# Technical Service Bulletin

| <b>Technical Service Bulletin:</b><br>TSB170066        | <b>Released Date:</b> 20-Mar-2018 |
| <b>New Diamond-Like Coated Steel Fuel Pump Plunger</b> |                                   |

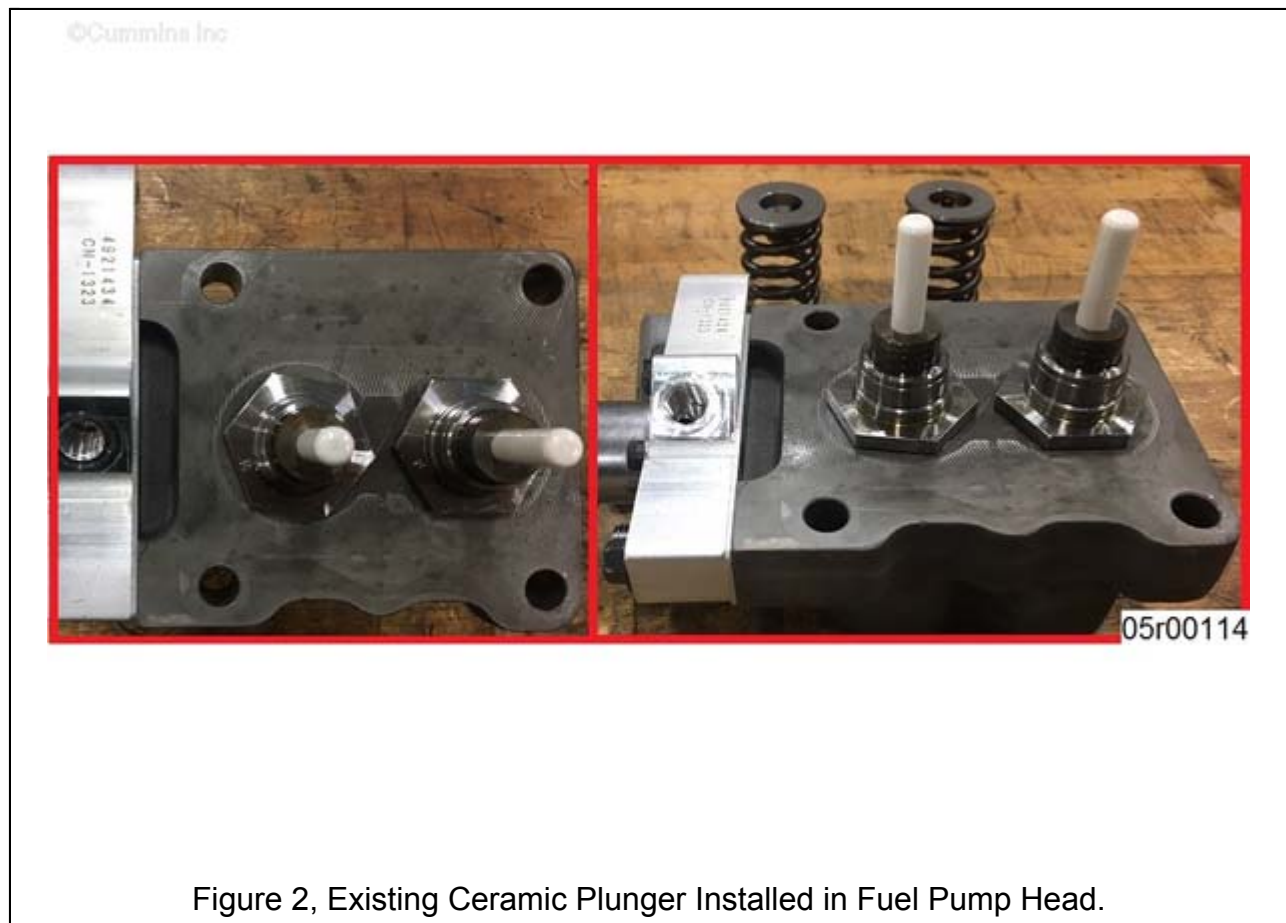
- Fuel pump head ceramic plungers have been replaced with steel diamond-like coated plungers.
- New diamond-like coated steel fuel pump plunger is available for service.
- See Figures 1, 2, and 3 in Part Identification section below for visual difference between ceramic and steel fuel pump plungers.

New diamond-like coated steel fuel pump plungers are more robust and are resistant to

fractures and breakage.

- Changing from ceramic to diamond-like coated steel plungers will require a quantity of two Service, Kit(s) Part Number 5472940. See Table 1 for part numbers.
- Troubleshoot any performance symptoms and active or recently inactive fault codes related to fuel system before proceeding. Example: no start or hard start or Fault Codes: 559, 1911.
- If ceramic fuel pump plunger(s) are damaged, inspect fuel pump head using reuse guidelines. See corresponding Service Manual. Reference Procedure 005-227 in Section 5. Repairs can be performed by replacing steel fuel pump plunger and barrel assembly with steel fuel pump plunger and barrel assembly kit. See Table 1 below for part numbers.
- Fuel pumps being repaired or inspected for any symptoms listed above **must** reuse original fuel pump head.
